In the Drawings

Discussion

FIG. 10

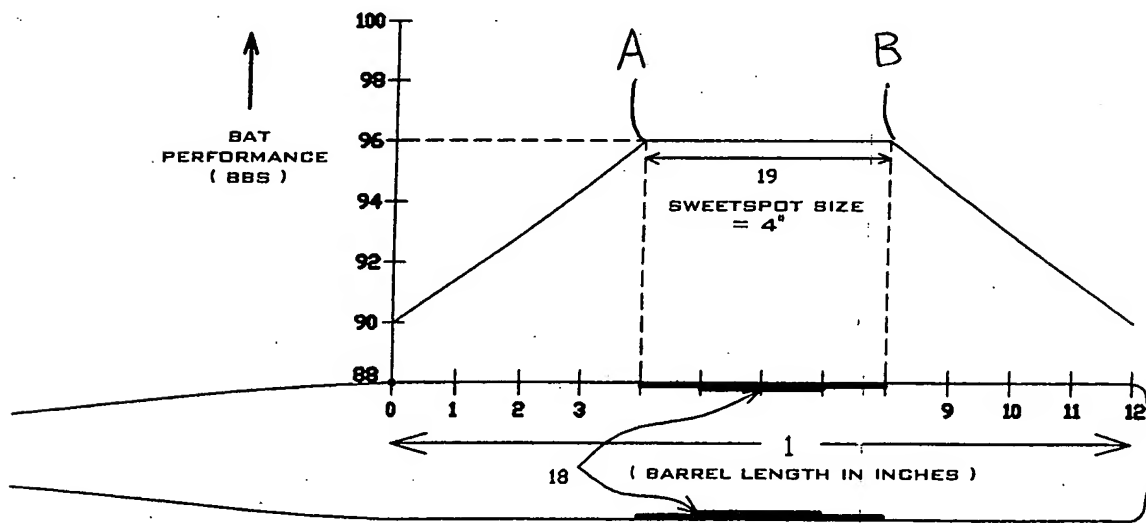
Please accept a sheet including an amended version of Figure 10 introducing the characters A and B as identifying inflection points on the curve of the graph. A second copy showing this change in red is also attached.

This amendment introduces the points A and B and verbalizes the flattened character of the batting performance curve there between. Such points and curvature were clearly apparent on Figure 10 and have merely been labeled. No new matter is being added.

[0060] In Figure 10, in an example of the present invention, the combined barrel wall, with the polymer composite stiffener 18 present, is approximately twice as stiff in the center 2 inches of the sweet spot area 19 as in the 1 inch area immediately adjacent to the center or mid-section area on each side of the center area. The polymer composite stiffener 18 fiber type, fiber angles and thicknesses are designed such as to reduce the bbs from 100 to 96 in the center 2 inch area of the barrel length 1 and from 98 to 96 bbs in the 1 inch areas immediately adjacent to the center area. As a result of the present invention, the resultant typical example bat meets the lowered regulatory standard of 96 bbs with a sweet spot area 19 which has been increased by 100% (from 2 inch wide to 4 inch wide). **At the same time the regions around points A and B have been introduced into the batting performance curve of Figure 10 that were not present in the curve of Figure 9, with the more flattened portion there-between that is characteristic of an extended sweet spot area 19.**
